Title - Sujet Steveston Paramount Wharf 403 Recon Reconstruction du quai 403 de Steveston Paramount	
Solicitation No. - N° de l'invitation F1571-210984/A	Amendment No. - N° modif. 003
Client Reference No. - N° de référence du client F1571-210984	Date 2022-01-11
GETS Reference No. - N° de référence de SEAG PW-\$PWY-028-9095	
File No. - N° de dossier PWY-1-44142 (028)	CCC No./N° CCC - FMS No./N° VME
Solicitation Closes - L'invitation prend fin at - à 02:00 PM Pacific Standard Time PST on - le 2022-01-25 Heure Normale du Pacifique HNP	
F.O.B. - F.A.B. Plant-Usine: <input type="checkbox"/> Destination: <input checked="" type="checkbox"/> Other-Autre: <input type="checkbox"/>	
Address Enquiries to: - Adresser toutes questions à: Lam (PWY), Tian	Buyer Id - Id de l'acheteur pwy028
Telephone No. - N° de téléphone (604) 363-7968 ()	FAX No. - N° de FAX () -
Destination - of Goods, Services, and Construction: Destination - des biens, services et construction: DFO – Steveston Paramount Wharf 403 – Richmond, BC

The Solicitation Amendment 003 is raised to issue Addendum 002.

Addendum 02

Q9. - Fish Plates

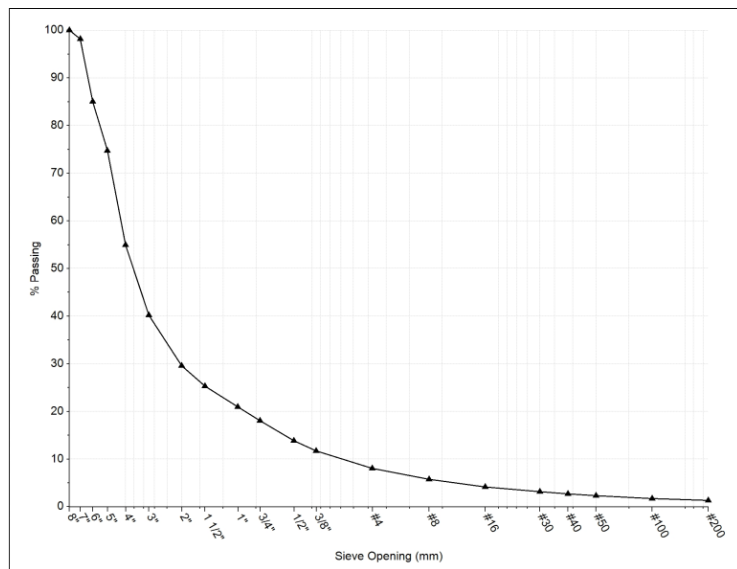
Please confirm each waler splice, comprised of 2 - C380x60 channels will require only 2 (not 4) fish plates.

A9. – 2 fish plates per waler splice.
